STAFF REPORT

SUBJECT: H-2022-0077 – Dutch Bros Ustick & Eagle MDA, CUP

The Applicant has submitted an application for a modification to the existing Development Agreement (H-2019-0082, Inst. #2019-121599) to update the existing concept plan; and conditional use permit to construct a new 1,154 square foot restaurant with associated drive-through on approximately 1.2 acres of land in the C-G zoning district.

F. Proposed Dutch Bros. Coffee Site Plan (date: 10/11/2022)

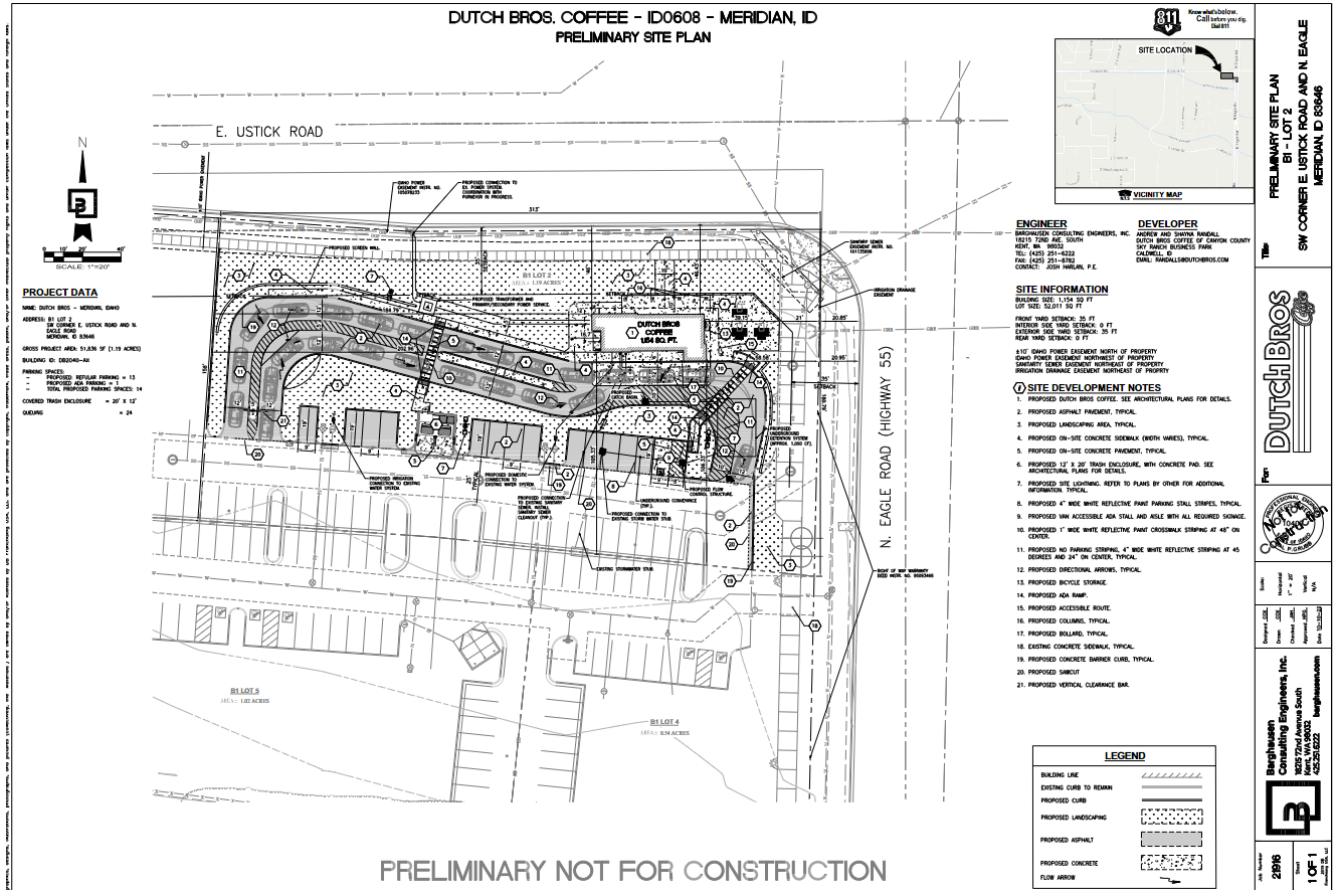
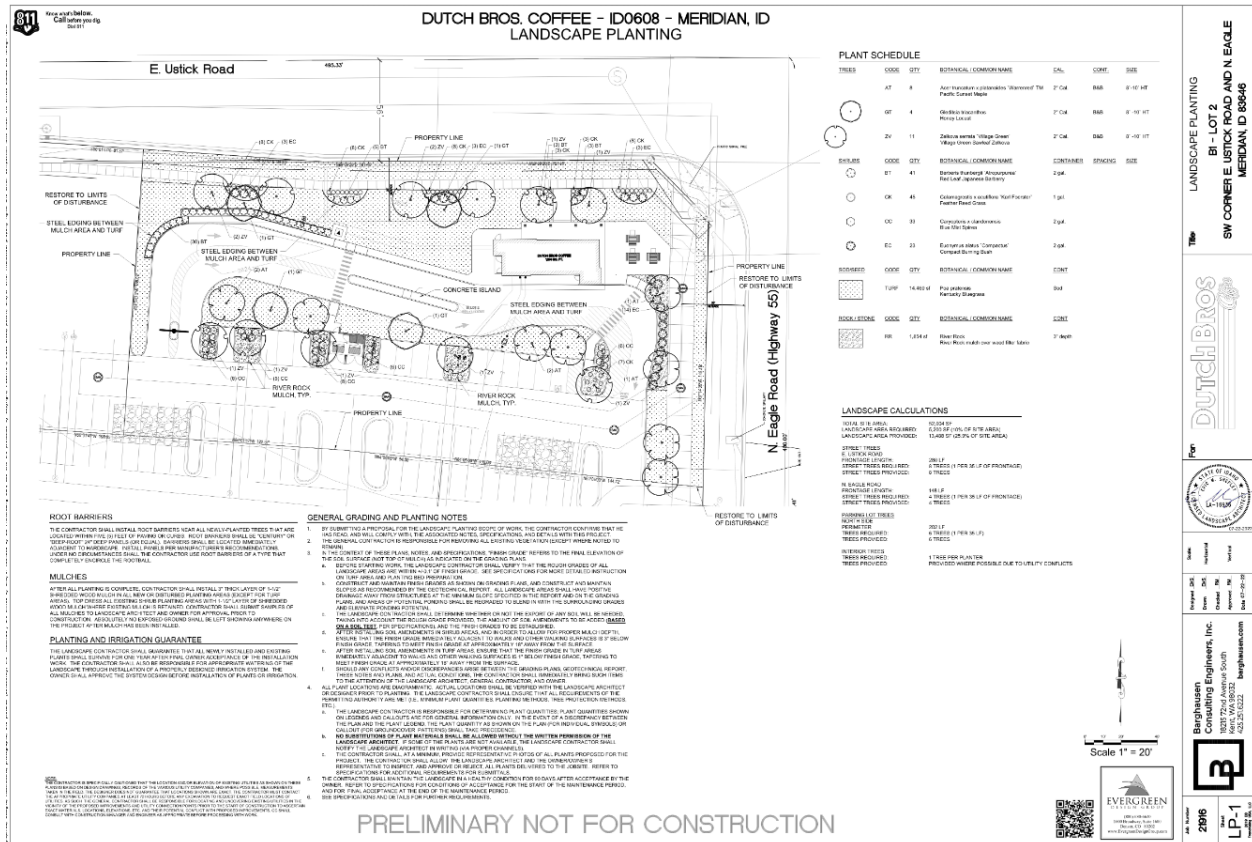
Drive-Through Establishment: The proposed drive-through establishment is subject to the specific use standards listed in UDC [11-4-3-11](#), Drive-Through Establishment. All establishments providing drive-through service are required to identify the stacking lane, menu and speaker location (if applicable), and window location on the site plan. *A menu board location should be depicted on the plans.* The site plan

The concept plan shows the stacking lane is a separate lane from the drive aisles and parking which provides access to the rest of the development. The proposed site layout places a drive-through that starts at the southwest side of the building and exits at the southeast side of the building facing N. Eagle Road. Approximately 524 feet of stacking space is available behind the drive-through window to provide queuing for up to 26 vehicles. Dutch Bros. coffee has proposed implementing a runner system at the facility that is designed to increase speed and efficiency in servicing the drive-through customers; as well, employees will travel from vehicle to vehicle to greet and take customer orders. The "Runners" will utilize a handheld device to transmit customer orders to the multiple drink stations inside the building. Additionally, "Runners" will charge customers while in line, so by the time they arrive at the service window, they may pick up their order and be on their way. This system decreases wait times while allowing the "Runners" to have a more personal face-to-face interaction with the customers. The drive-through will not include any speaker boxes. All customer orders are taken in person either at the window or with a runner that carries a handheld device to transmit orders to the kitchen. This order process will minimize noise impacts and also decrease the amount of vehicle idling at menu boards that are common at traditional drive-through facilities. If there was additional or excessive overflow from the drive-through lane which does sometimes occur from drive-through establishments at peak times, it would stack into the parking lot from the west, not into N. Cajun Lane or E. Ustick Road.

The stacking lane exceeds 100' in length and an escape lane is required. An escape lane is proposed prior to approaching the ordering window on the southeast side of the building.

The drive-through is located on the south side of the building and is visible from the N. Eagle Road and the drive aisle along the south side of the building for surveillance purposes.

Pedestrian Walkways: A pedestrian walkway is proposed from the pation on the east side of the building to the pedestrian pathway along Eagle Road as required by UDC 11-3A-19.B.4.

Parking lot: Landscaping is required in the parking lot per the standards in UDC 11-3B-8C.1. **The perimeter landscape buffer shall be planted with one Class II or Class III tree per thirty-five (35) linear feet and shrubs, lawn, or other vegetative ground cover. The perimeter landscape buffer next to the drive-through lane on the west side of the site is missing a mix of trees, shrubs, and River Rock mulch on the landscape plan submitted with the CUP. All other landscaping appears to comply with UDC standards.**

2. The site plan and landscape plan submitted with the Certificate of Zoning Compliance application shall be revised as follows:
 - a. The stacking lane, and menu location(s), and window location shall be depicted in accord with UDC [11-4-3-11B](#).

- c. Additional signage and parking lot striping is required throughout the site to efficiently and adequately direct patrons to the menu boards and throughout the site with minimal conflict.

- f. Depict landscaping in the perimeter buffer along the drive aisles and drive-through lanes in accord with the standards listed in UDC [11-3B-8C](#); the perimeter landscape buffer shall be planted with one Class II or Class III tree per thirty-five (35) linear feet and shrubs, lawn, or other vegetative ground cover. With the CZC submittal, the landscape plan shall be revised to show the required mix of materials (i.e., trees, shrubs, River Rock Mulch) in the parking lot perimeter landscape buffers to the north, south, and west of the drive-through lanes.

- f. Depict signage ahead of each pedestrian crossing in the drive-through lane notifying drivers to watch out for pedestrians.
3. Compliance with the standards listed in UDC [11-4-3-11](#)– Drive-Through Establishment and standards listed in UDC [11-4-3-49](#)– Restaurant is required.

H. Dutch Bros. Coffee Proposed Elevations (Not Approved)

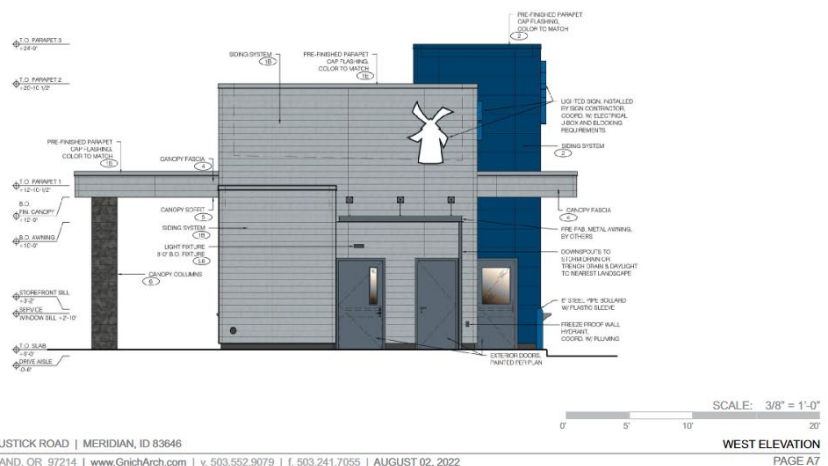
Conceptual building elevations were submitted for the proposed structure as shown in Section VII.E. Building materials consist of fiber cement siding, CMU Willamette-Graystone, metal roofing, canopy soffit in natural north-western spruce, and glazing. The elevations appear to generally comply with the standards in the Architectural Standards Manual; however, a detailed review will take place with the administrative Design Review application.
